February 18, 2022

Garvin Design Group
1209 Lincoln St.
Columbia, SC 29201

ADDENDUM NO. 3

PROJECT TITLE
COASTAL CAROLINA UNIVERSITY
LIBRARY LEARNING COMPLEX
 STATE PROJECT NUMBER: H17-9615-MJ
 370 UNIVERSITY BLVD.
 CONWAY, SC 29526

01 PAVER SYSTEM 'A/B/C'
SCALE = NTS

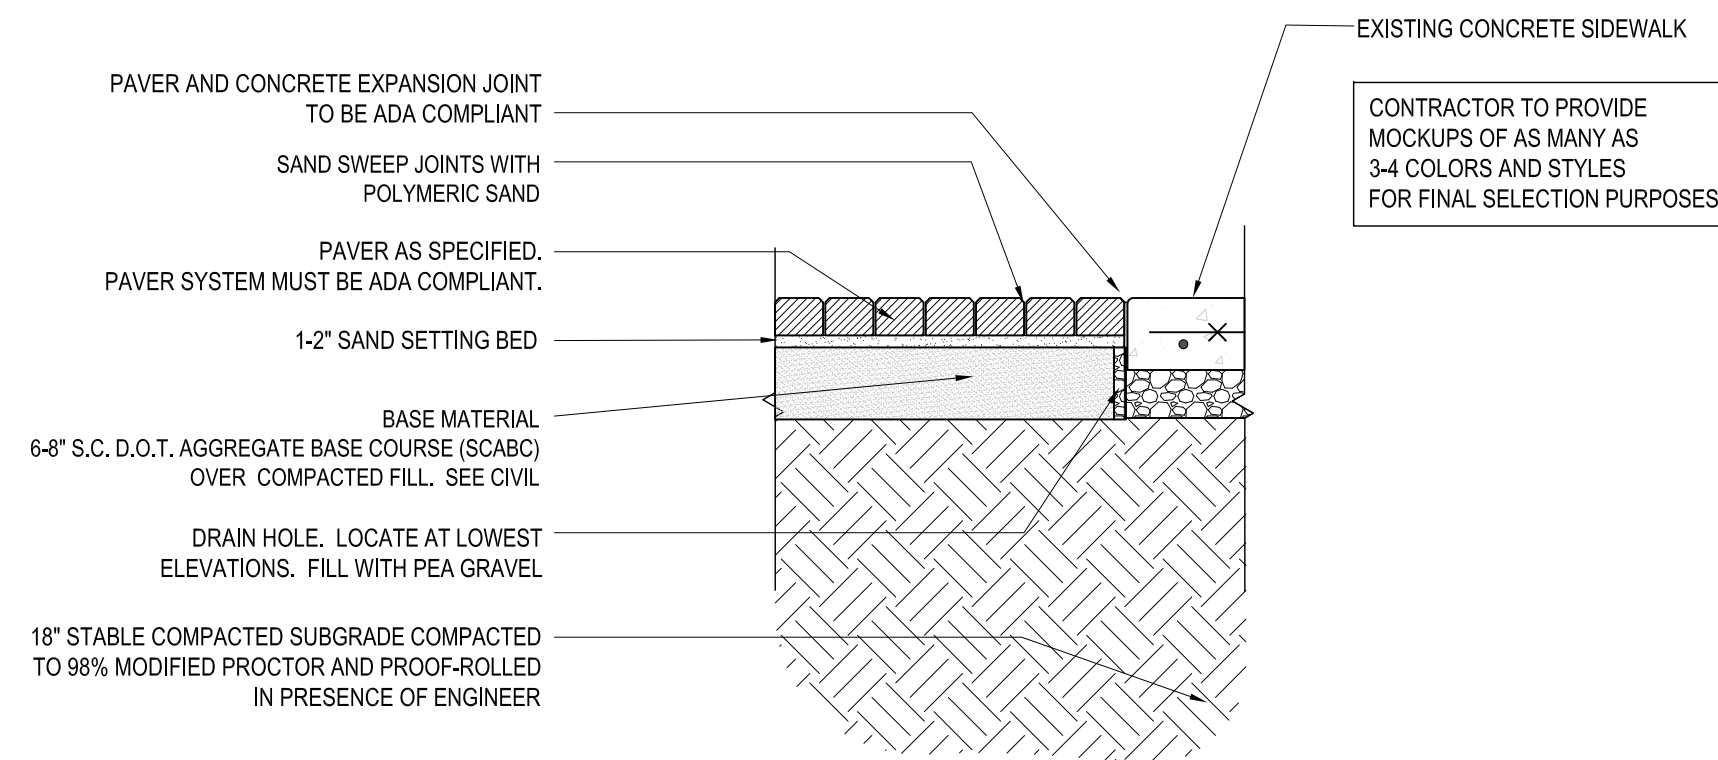
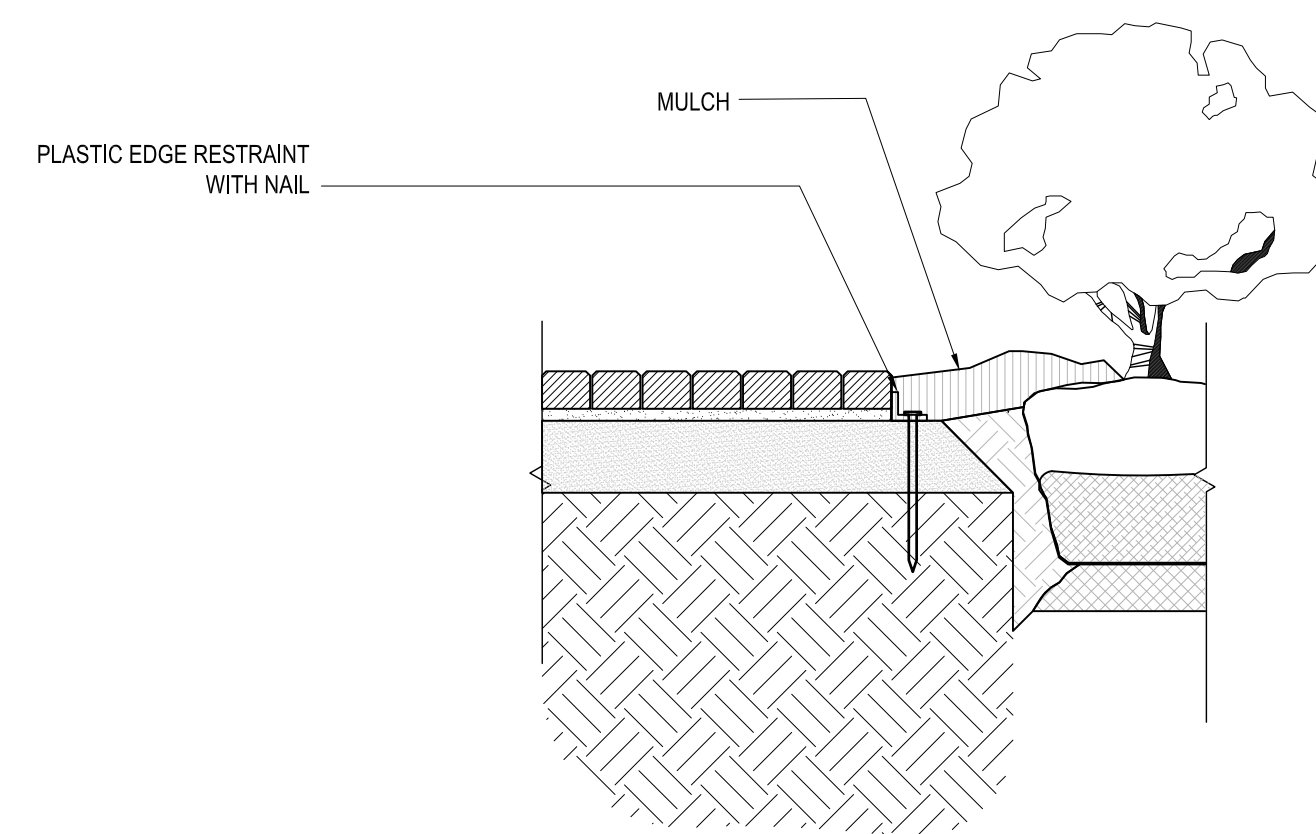
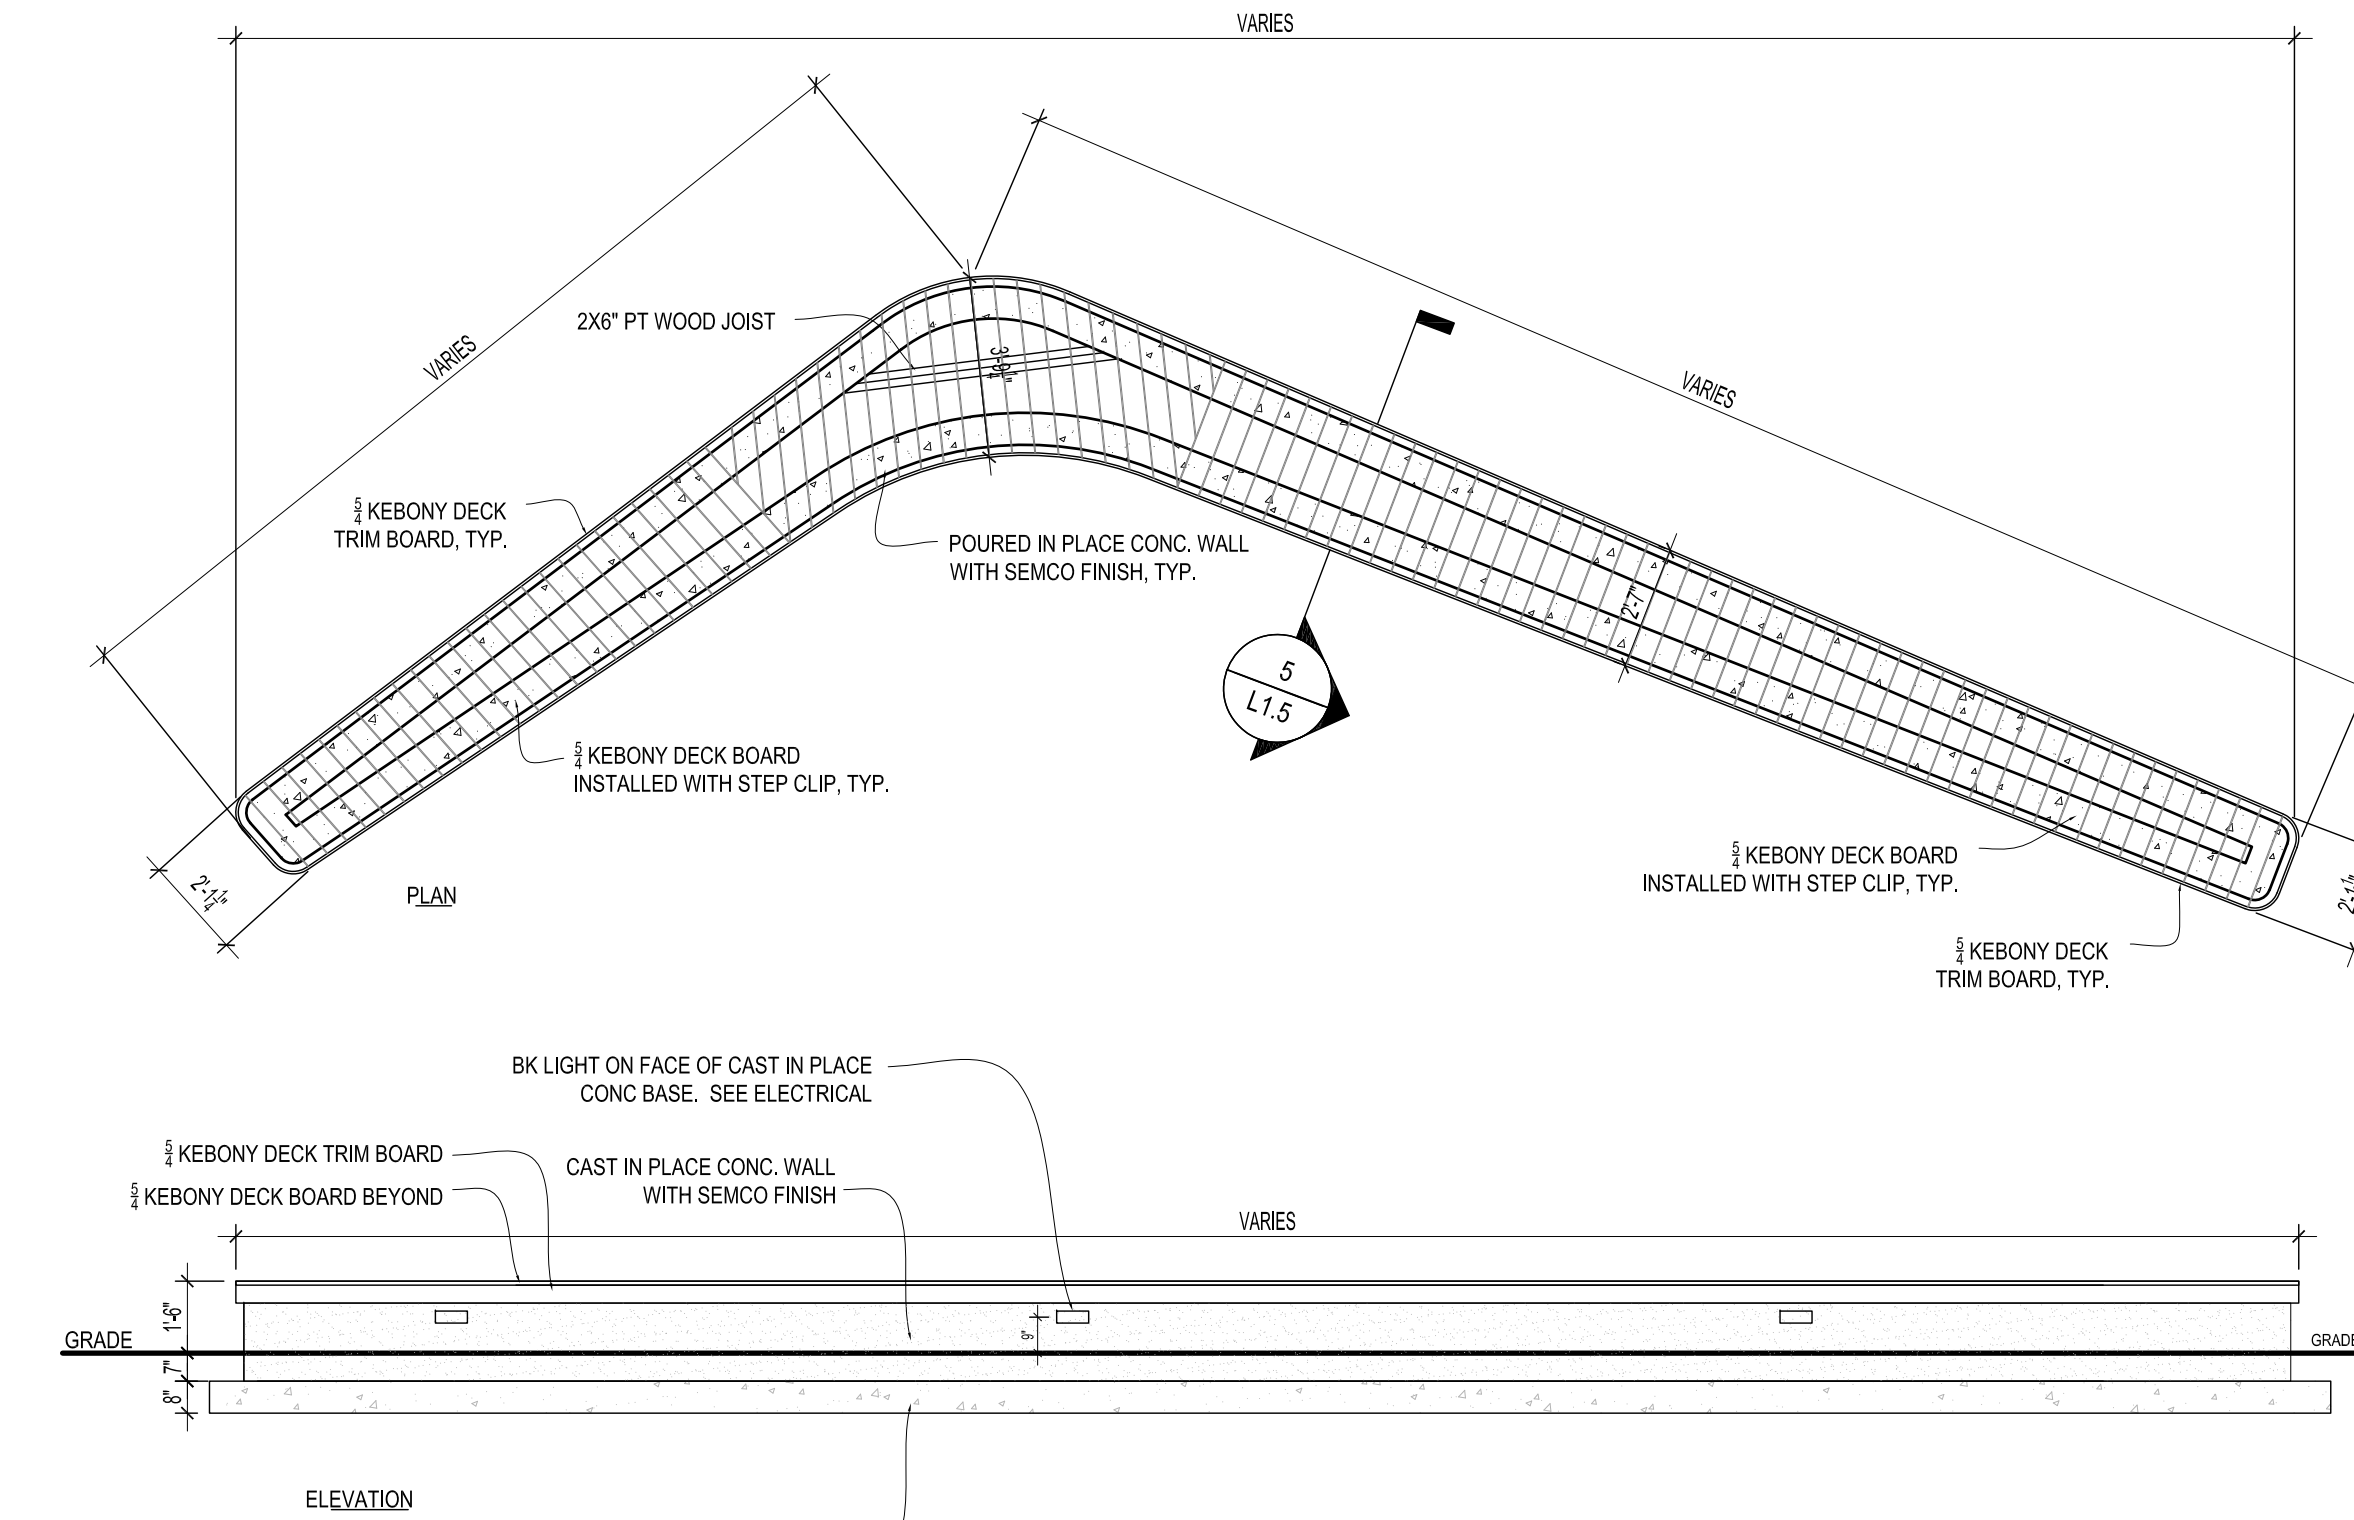
| 1. | <u>Revision:</u> Reference Drawing L1.5 for clarification on concrete pavers. |

PROJECT NO. CSM/19
DATE 01-14-22
DRAWING NO. **A7.10**

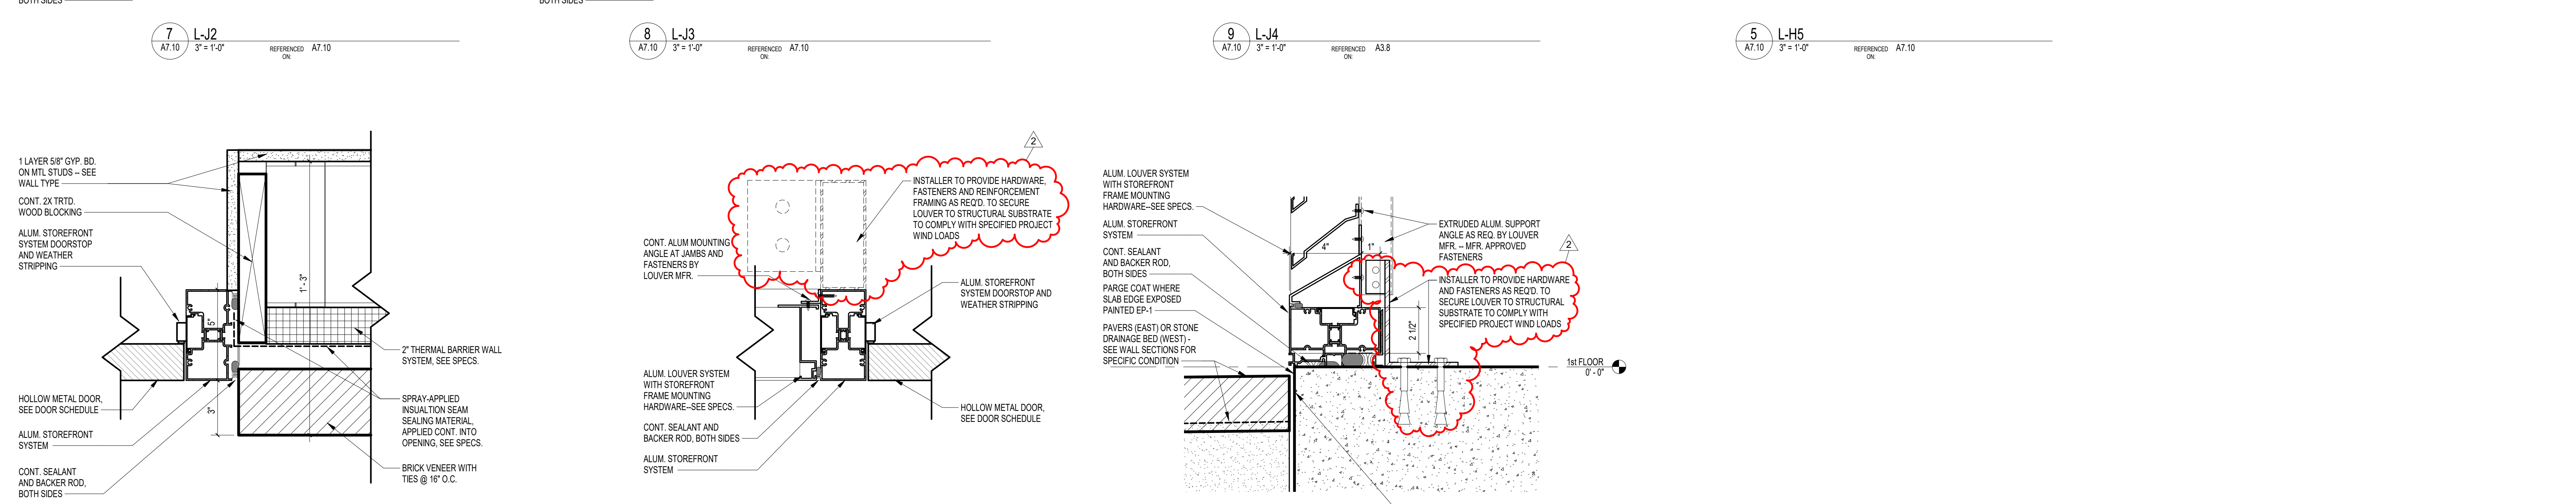
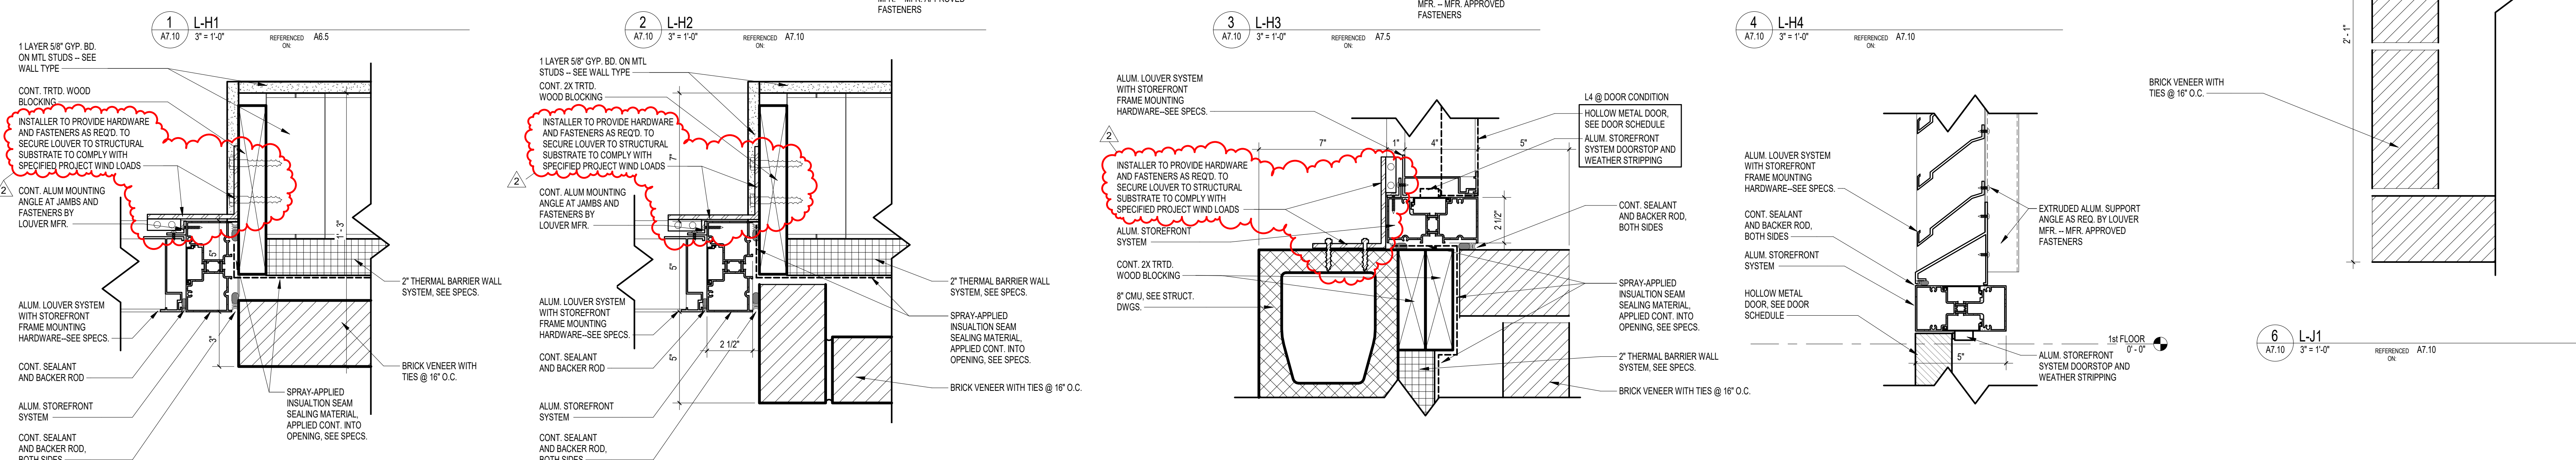
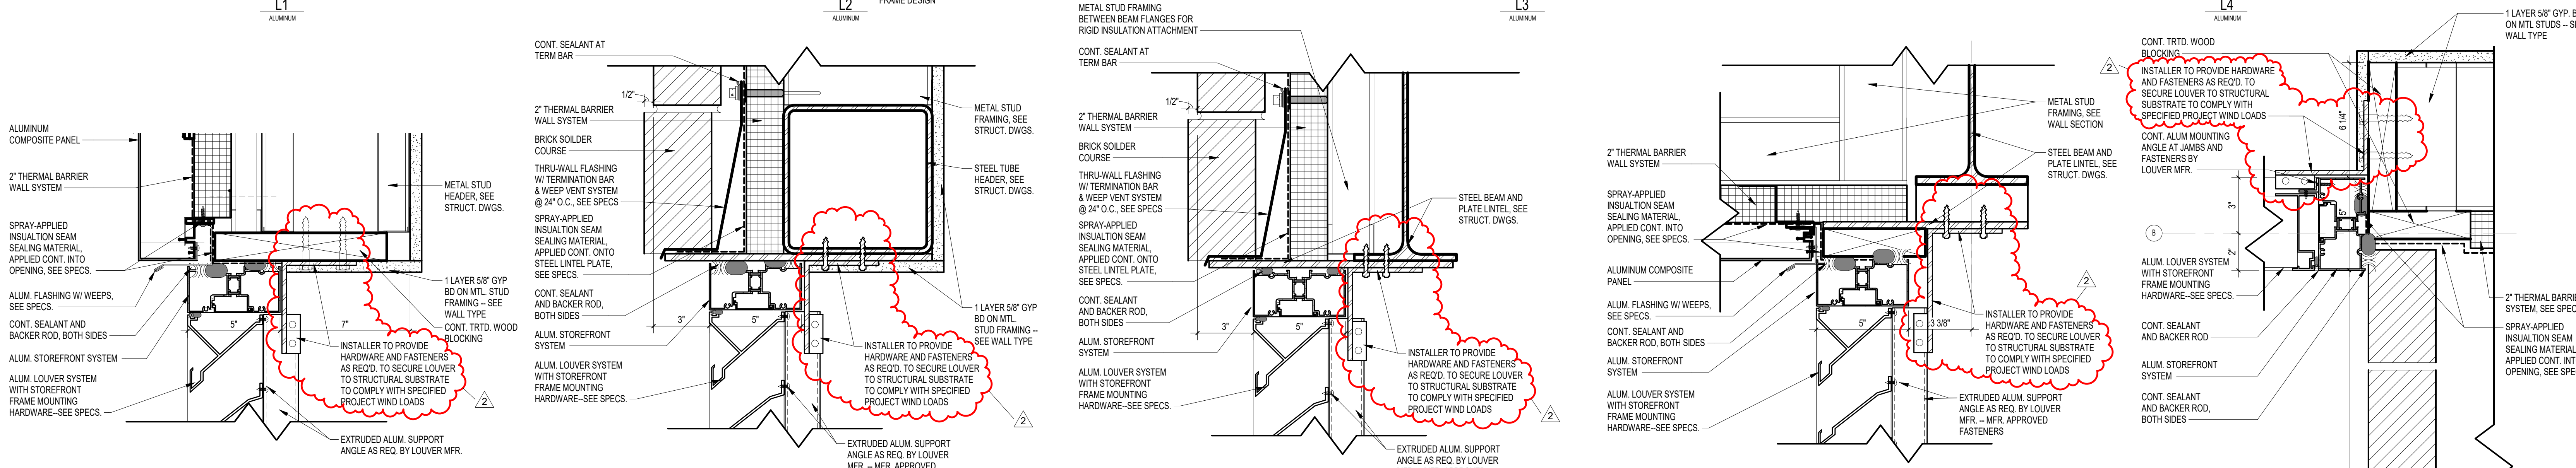
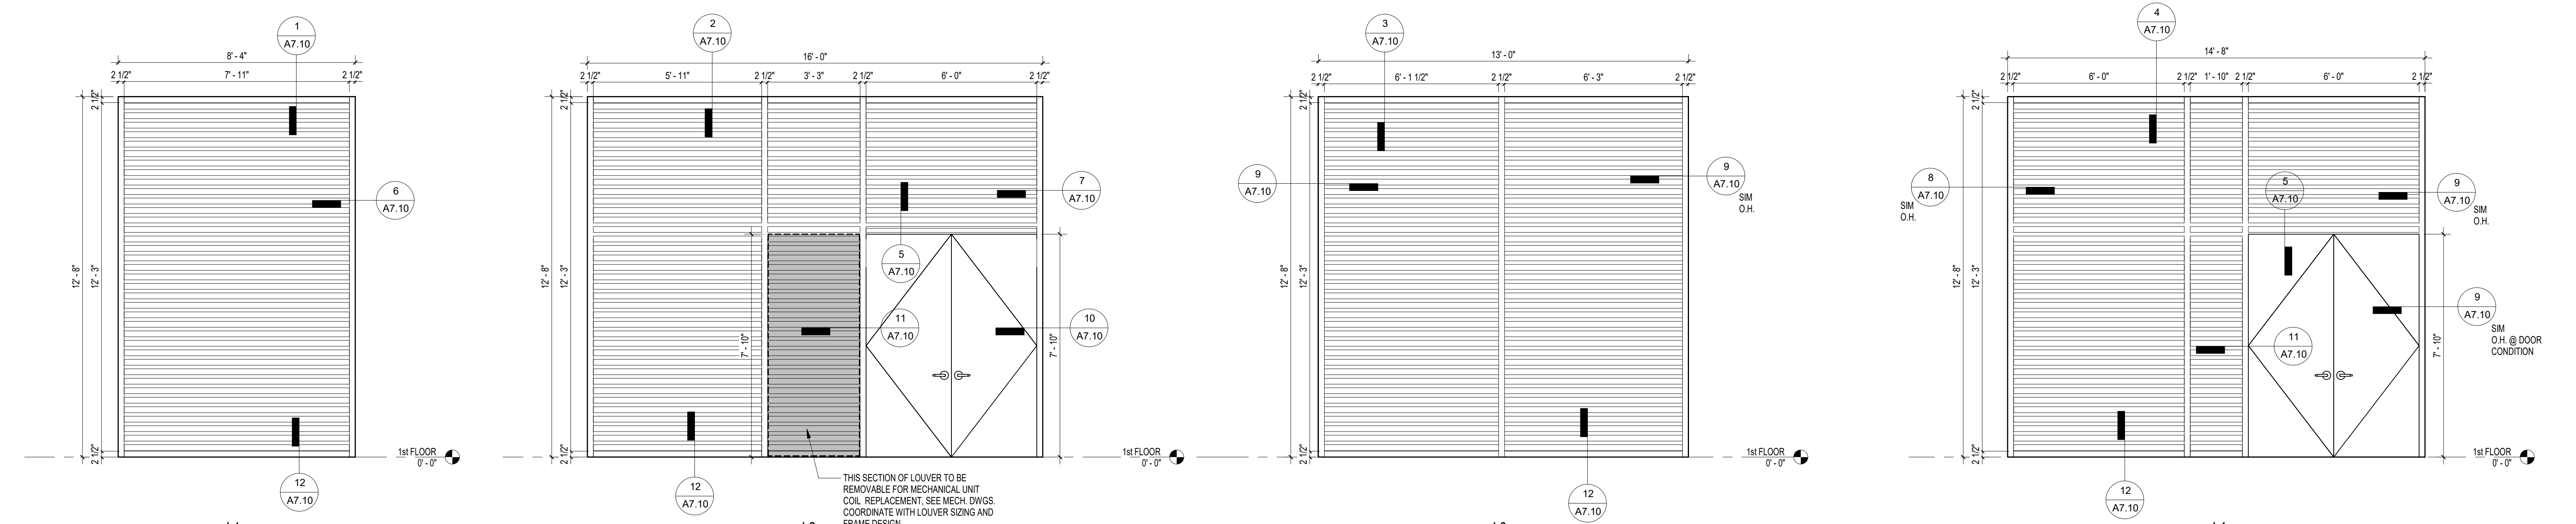
| 2. | <u>Revision:</u> Reference Drawing A7.10 for additional louver attachment detailing. |
